# Presentation to the ACRS Subcommittee

## **Safety Review of the Clinch River Nuclear (CRN) Site, Early Site Permit Application**

### **Chapter 2, Section 2.5: Geology, Seismology, and Geotechnical Engineering**

October 17, 2018

SSAR Figure 2.5.2-26

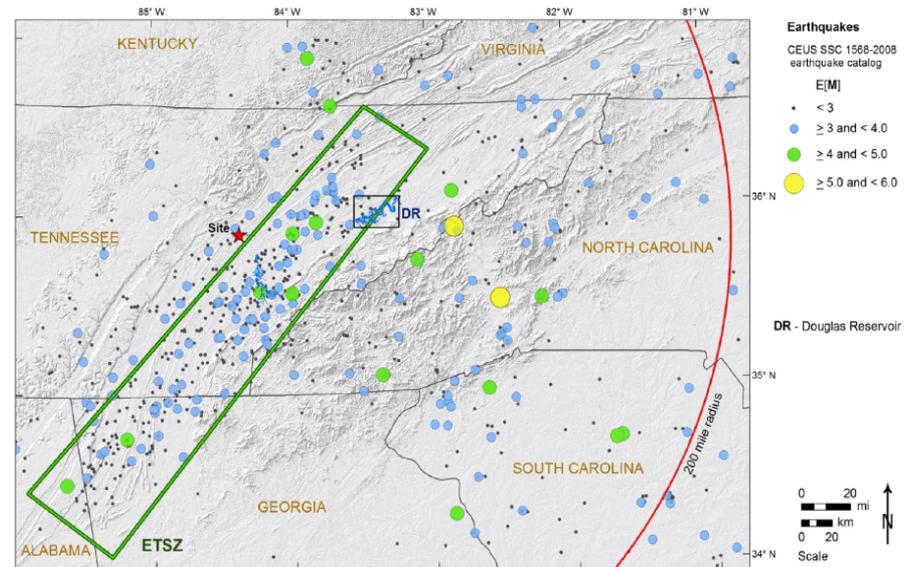
- Applicant performed two sensitivity studies following SSHAC guidance for Level II study
  - Evaluate  $M_{\max}$
  - Evaluate Magnitude-Frequency relations
- $M_{\max}$  values in NUREG-2115 encompass proposed  $M_{\max}$  developed using new data
- Recurrence of large magnitude events in NUREG-2115 consistent with proposed values in new geologic studies
- Staff concludes that NUREG-2115 adequately captures current understanding of seismic hazard in the Eastern Tennessee Seismic Zone

# Probabilistic Seismic Hazard Analysis (PSHA) Confirmatory Calculations

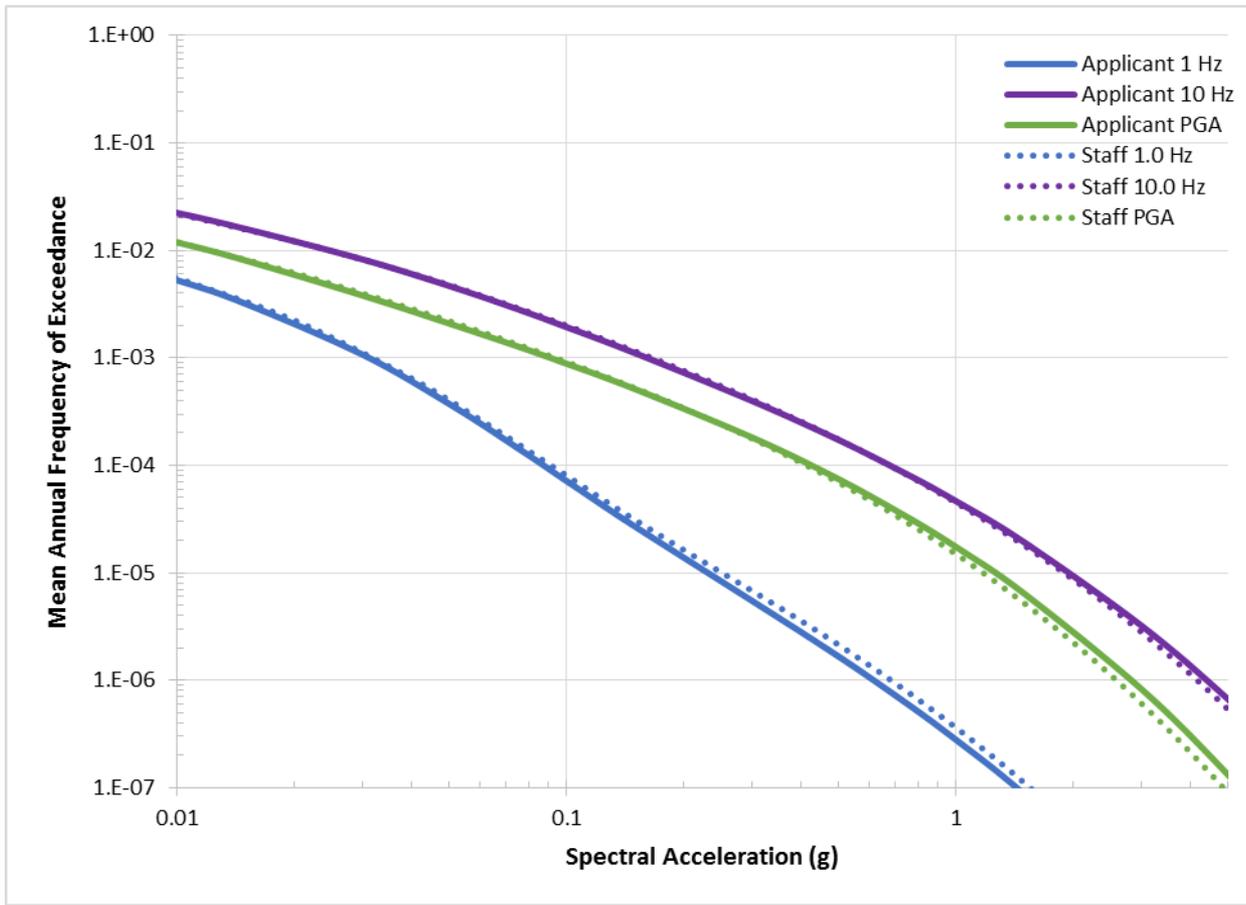
Staff independently calculated seismic hazard curves at the Clinch River site. Comparisons show that the seismic hazard curves are in good agreement at the annual frequency of exceedances of interest:  $10^{-4}$ ,  $10^{-5}$ , and  $10^{-6}$ .

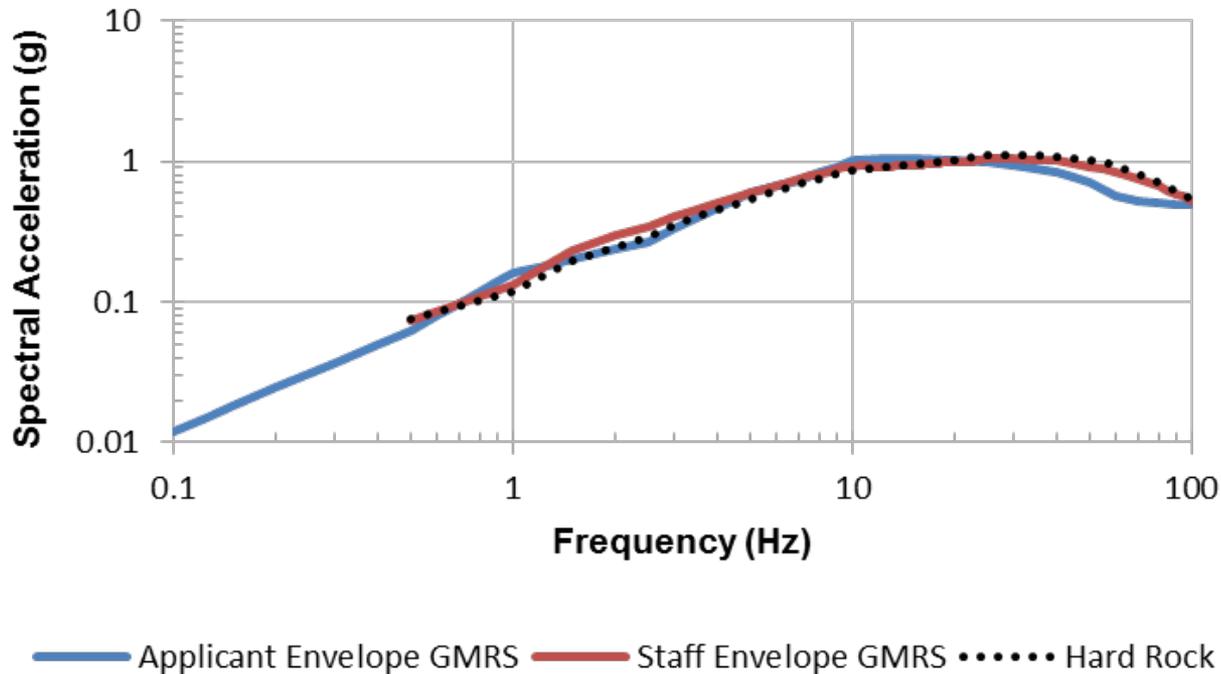
- Clinch River site has significantly dipping rock layers
  - Approximately 30 degrees
- High seismic velocities
  - 5,000 to >10,000 fps
- Applicant developed site response inputs using

- 3 profiles for each location
  - Log mean seismic velocity as function of depth as base case
  - Upper and lower case using log standard deviation
  - Effect of smearing geologic units together

- Staff requested that applicant explain how the use of multiple base cases accurately accounts for dip across site
- Applicant responded the smearing of units is appropriate because mean and range of values at a specific depth is maintained, implicitly accounting for stratigraphic variations.

- Staff performed confirmatory site response considering dip explicitly (i.e. upsection; middle; and downsection profiles)
- Staff truncated profiles at the top of the Knox Group due to thickness and velocity of layer

- Staff's results are consistent with applicant's

SSAR Figure 2.5.2-108

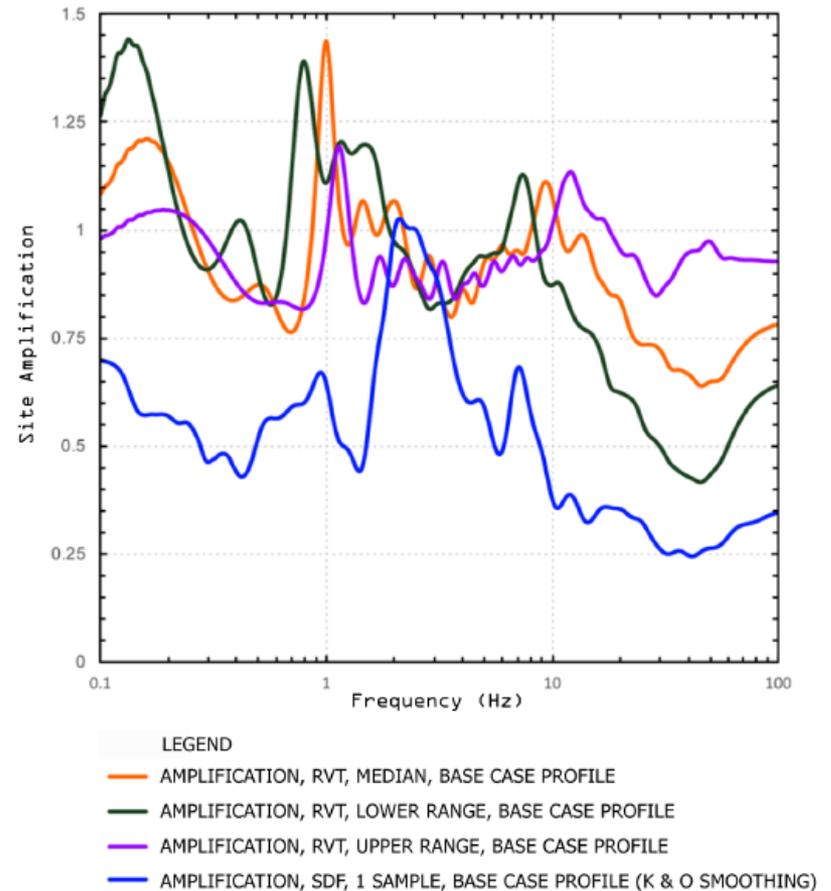
- Clinch River site has significantly dipping (>30 degrees) rock layers in subsurface
- RG 1.208 states that for sites with complicated subsurface structure, a multi-dimensional approach to site response may be necessary
- Applicant developed a 2-D site response analysis and compared amplification functions to 1-D results developed using 2-D inputs
- Staff requested that applicant compare 2-D results to 1-D results used in developing GMRS
- Applicant's 2-D results compare favorably with 1-D results, satisfying staff's concern
